MSEX3024A-03

S E R V I C E N O T E

MSEX3024A – Oscilloscope, Mixed Signal, 4+8 Channel,
200MHz

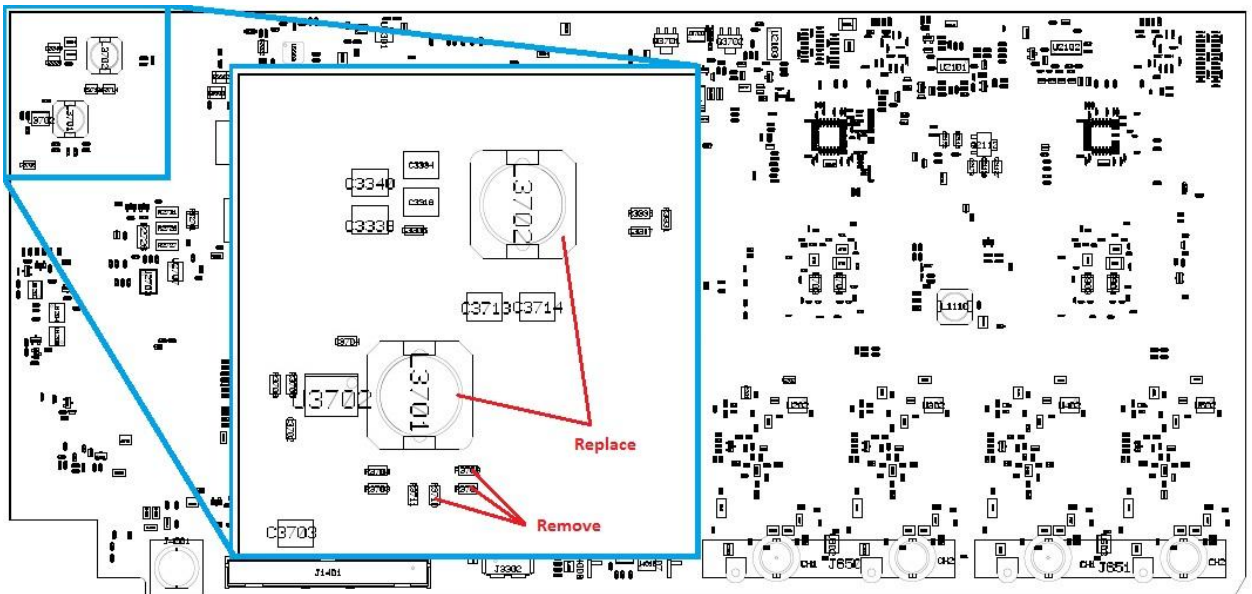
With the oscilloscope power turned on and while under normal operation, the unit emits a hissing noise.

2. As the picture indicates, remove the three resistors (0699-7209, 1 Ohm) located at R3701, R3709, and R3710. They are not to be replaced.
3. Remove as well the two inductors (9140-6474, 100uH) located at L3701 and L3702 and replace them with inductors with part number 9140-6151 (68 uH).
4. Re-assemble to the point where the unit could be powered up to verify that the hissing is indeed gone. If the hissing is not gone, please, check modifications.
5. When the hissing is gone, put oscilloscope back together.
